MSC APOLLO 13 INVESTIGATION TEAM

PANEL 6

RELATED SYSTEMS EVALUATION

VOLUME I
SUMMARY

FIGURE A-3.- 1 CM POTABLE AND WASTE WATER QUANTITY TRANSDUCER.

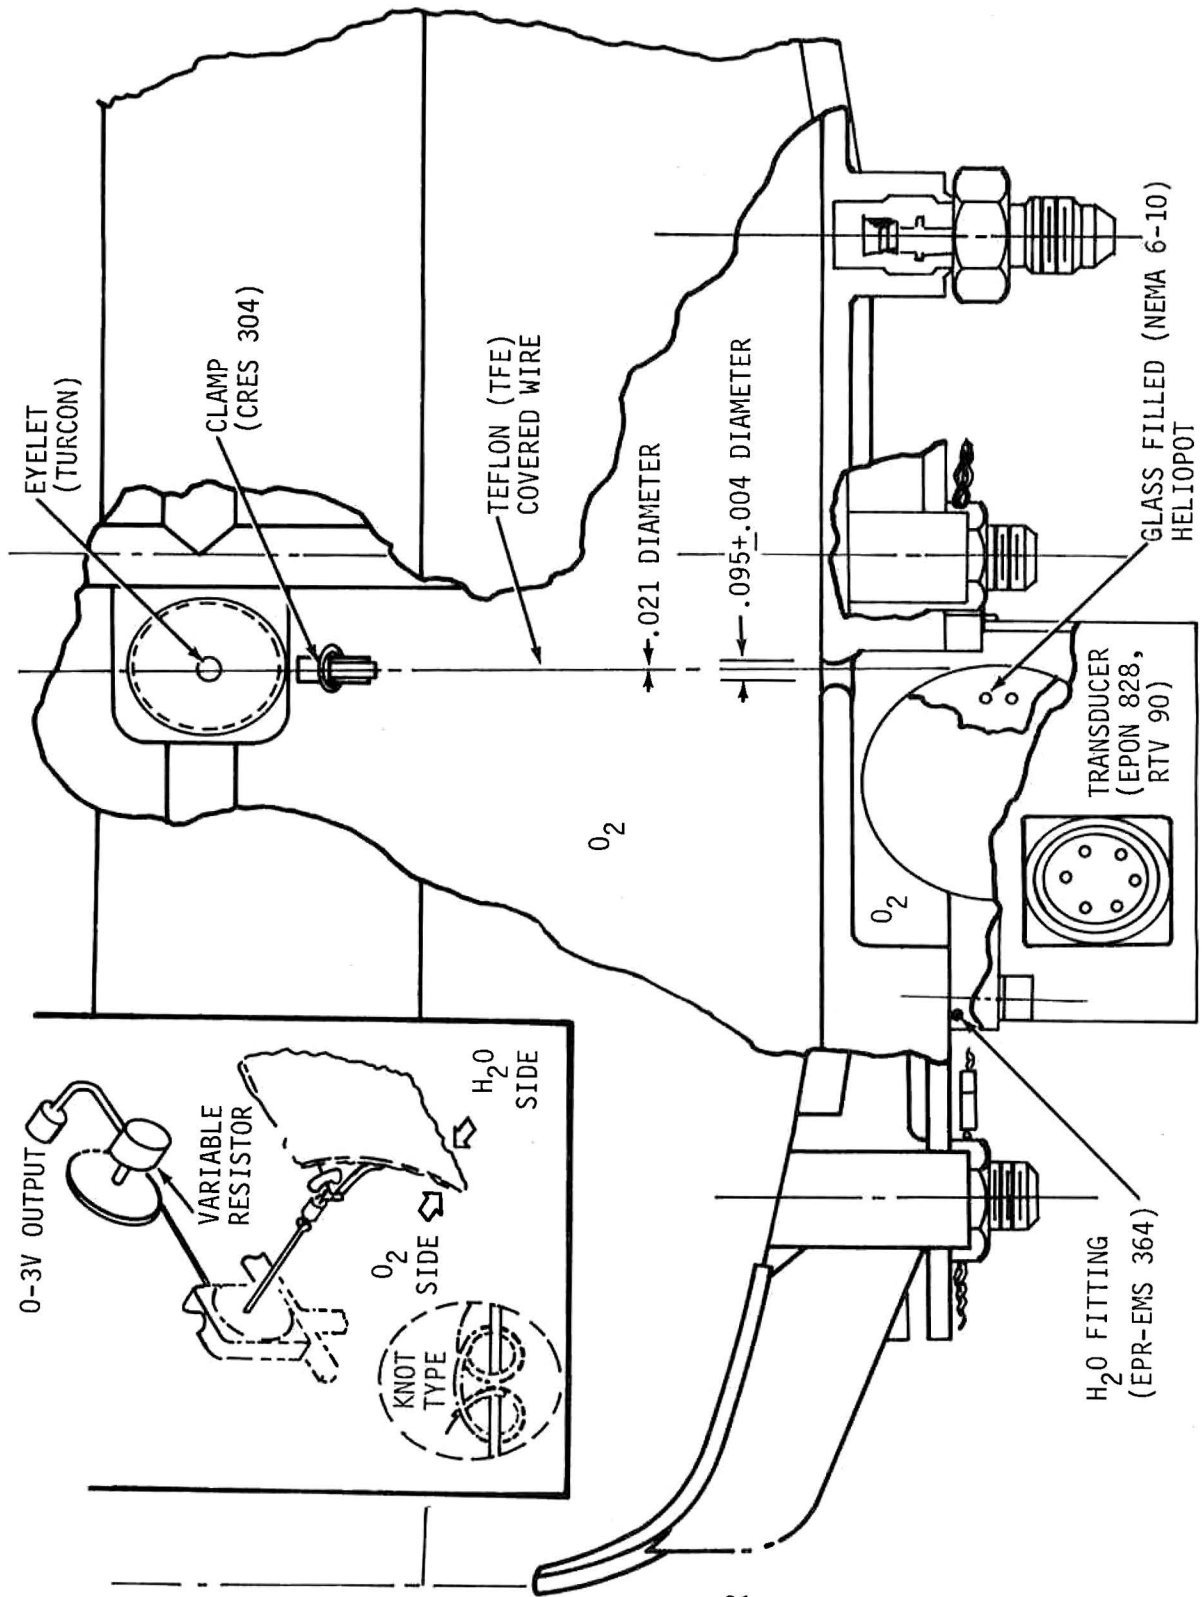
The quantity gaging system (including the electronics) in the potable water and waste water tanks is exposed to oxygen at pressures of 25 psia during flight and 35 psia during countdown. The electronics is supplied by 28 Vdc through two 5 amp circuit breakers. The acceptability of this design will require additional ignition tests which have already been initiated.

Perform analyses of the water quantity gaging system to determine the integrity of the transducer cover and the non-propagation of flame to the bladder for a worst case short in the transducer. If the results indicate a marginal factor of safety, perform a test using actual hardware for both flight and ground conditions. At the same time, the requirement for a water quantity gaging system should be re-examined to determine if it is mandatory for flight.

FIGURE A-5.- OXIDIZER PROBE ASSEMBLY.

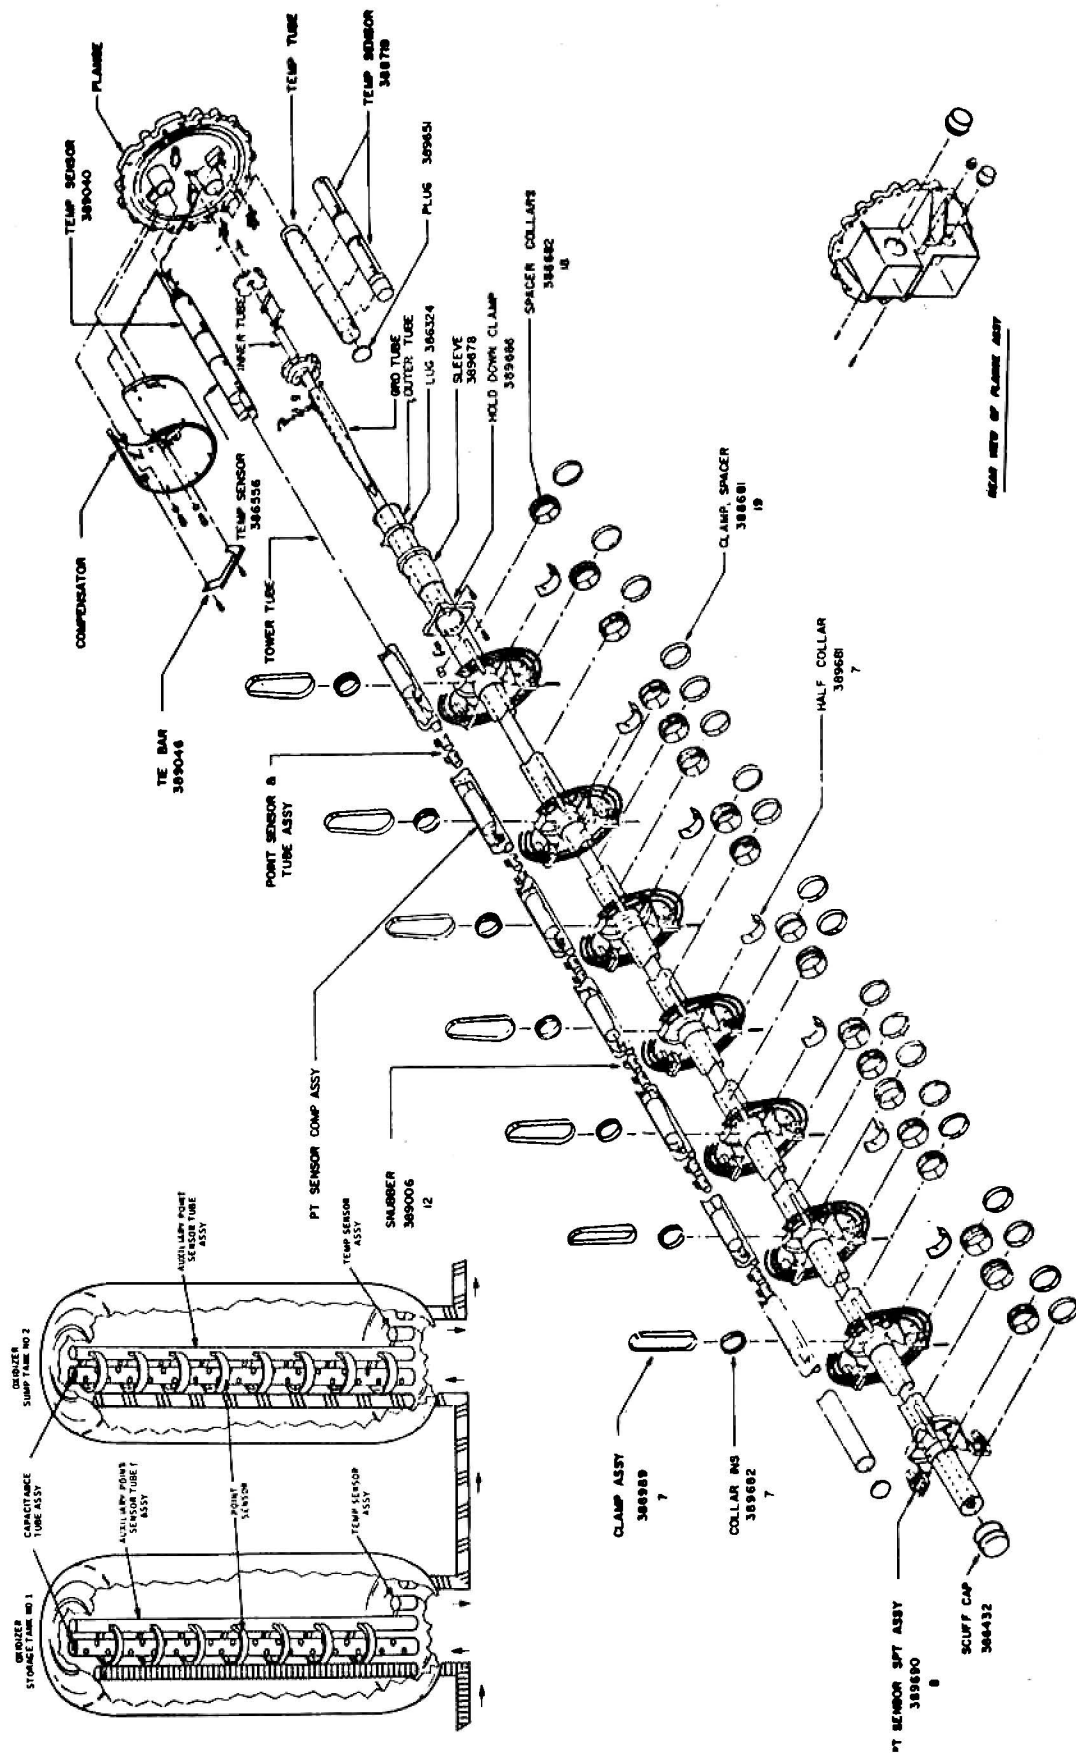
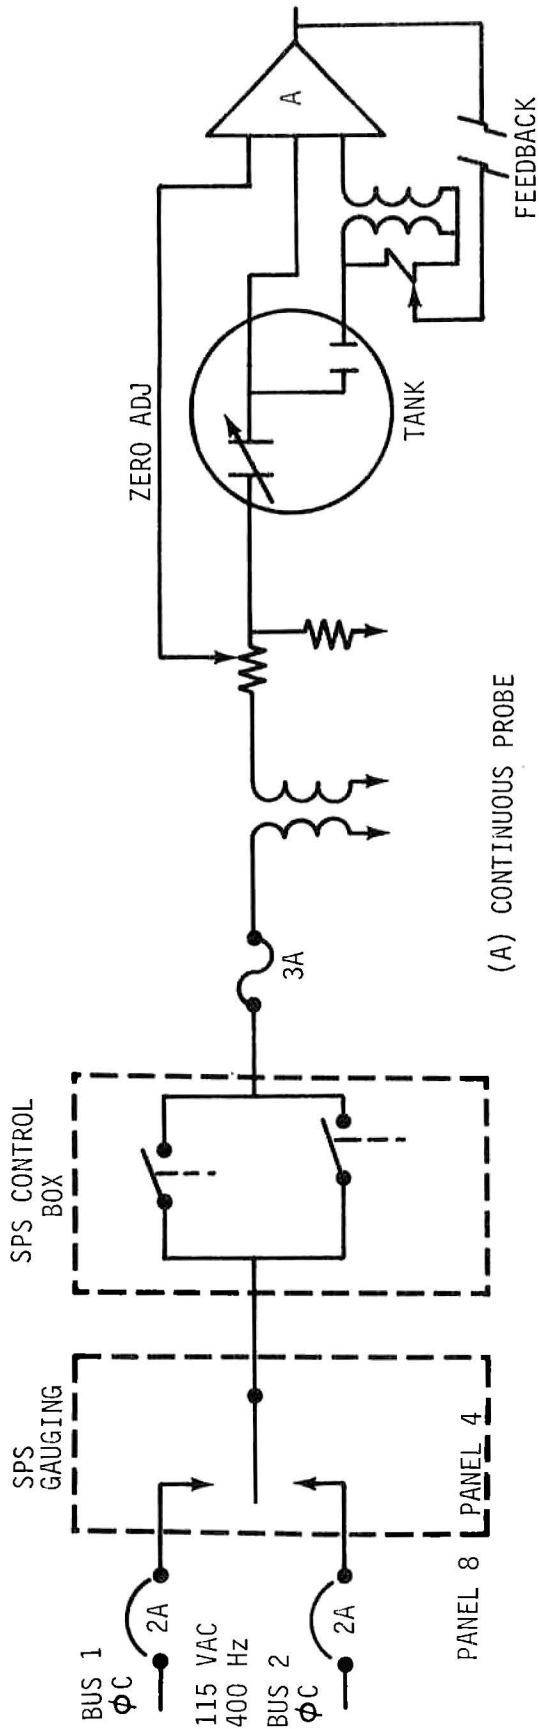
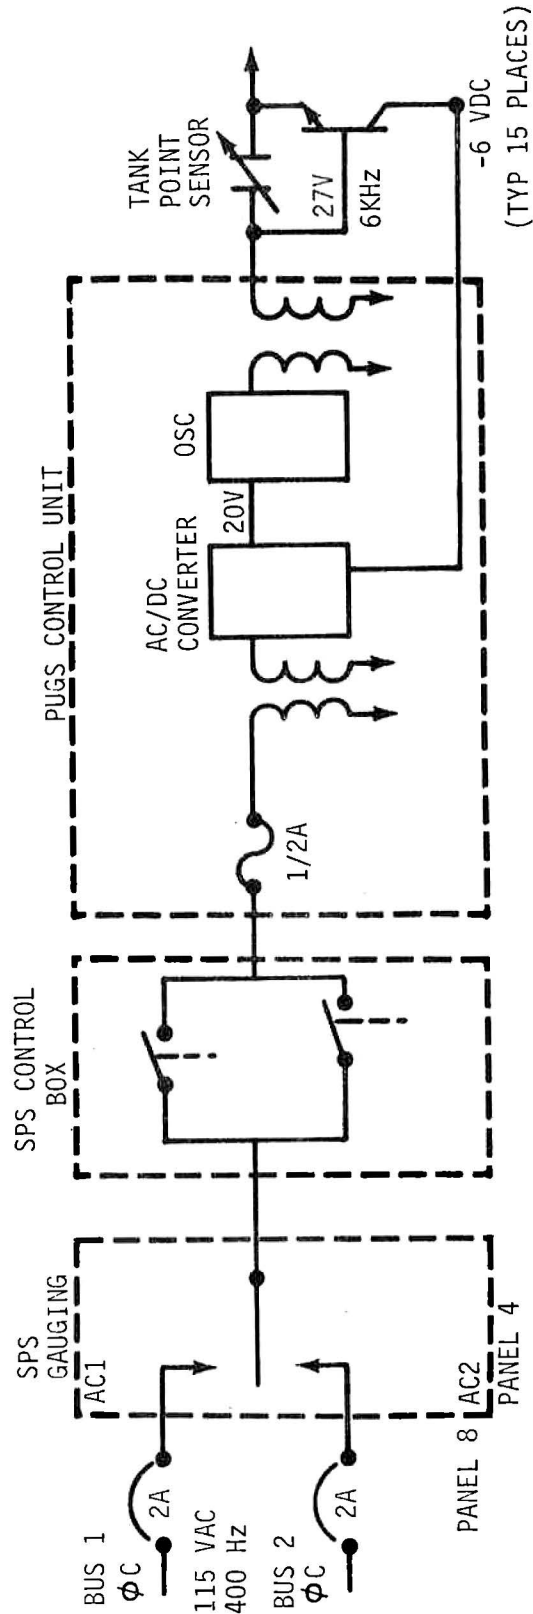
It was not possible to establish the acceptability or unacceptability of the direct contact of electrical components and Teflon with oxidizer and fuel which exists in the SPS quantity gaging sensors. Analysis indicates there should be no problem. Test have been initiated to confirm this analysis.

Complete the testing already initiated to determine whether sustained reactions can be initiated in the SPS quantity gaging sensors within the energy limits of each application.

FIGURE A-7.- PQGS SENSOR.

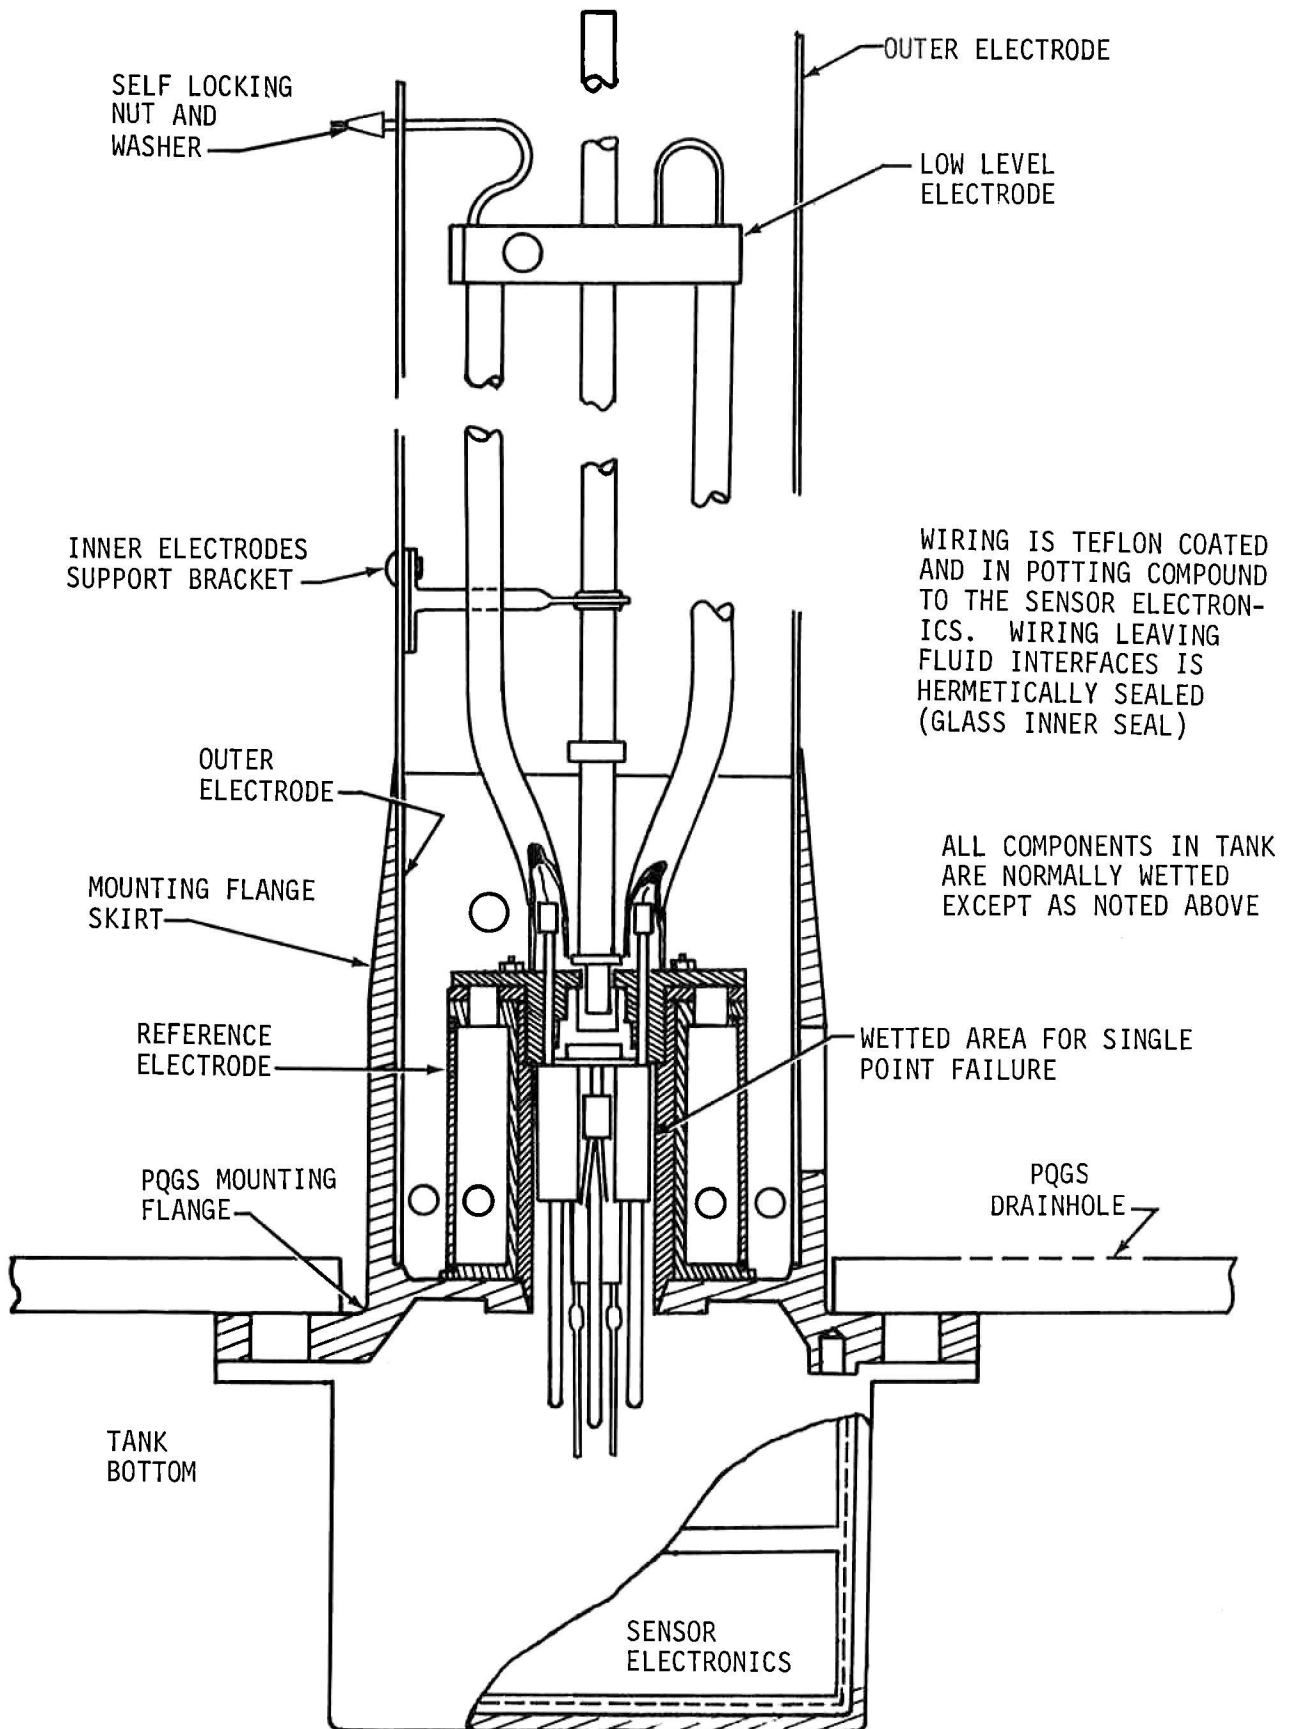
a. None of the electrical components investigated constitute ignition sources in their normal operating modes. Only the PQGS normally exposes electrical devices directly to the pressurized fluid. After thorough analysis it is concluded that adequate circuit protection is provided to preclude ignition.
